1970 - 1973 Corvette: Service Bulletin: Engine Overheat

Model and Year: 1970 - 1973 Corvettes with 454 Cu. In. Engines and Air Conditioning

Bulletin Number: 73-T-28, Section VI

Date: May 14, 1973

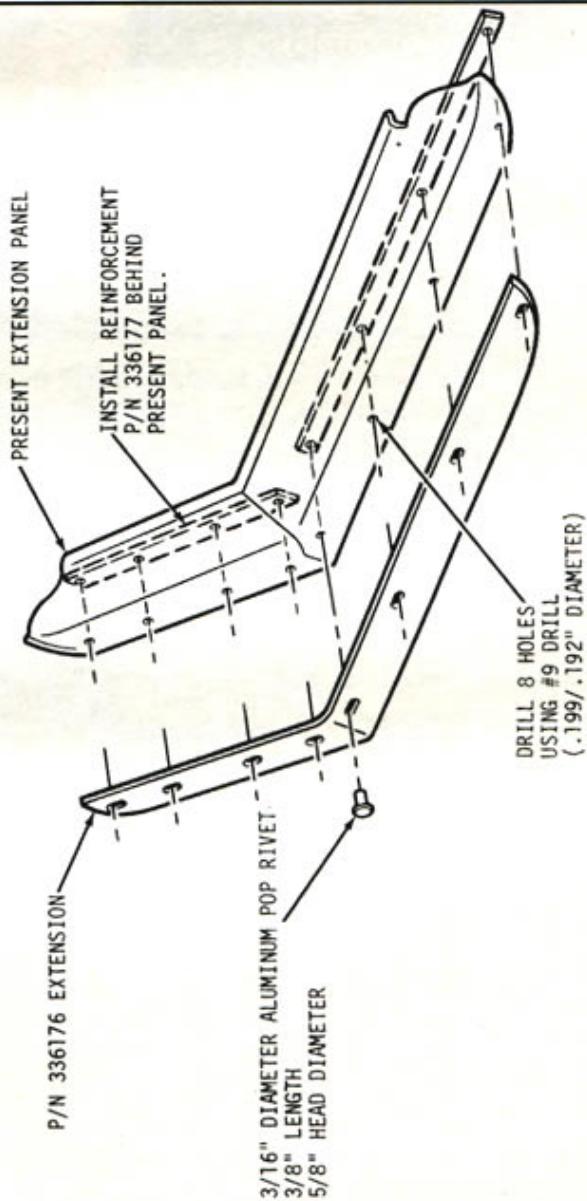
Engine overheating may be encountered on some 1970-1973 Corvettes equipped with the 454 cu. in. engine and air conditioning during high ambient temperatures when operated in heavy traffic. This condition is due to the limited amount of air flowing through the radiator at low vehicle speeds or during periods of extended idle.

To improve low speed cooling, an additional grille panel lower extension was installed in 1973 Corvettes produced after Vehicle Identification Number 1Z37Z3S410722. This extension, Part Number 336176, may be installed as illustrated on page 2 of this bulletin on early 1973 Corvettes only .

In addition, a flex fan that provides increased air flow through the radiator has been released for service use on any 1970-1973 Corvette with 454 cu. in. engine and air conditioning. This fan replaces the original fan and fan clutch assembly and may be ordered in a kit, Part Number 6260480, that includes the necessary attaching parts. When using the flex fan, an increase in fan noise may be noticed under some driving conditions.
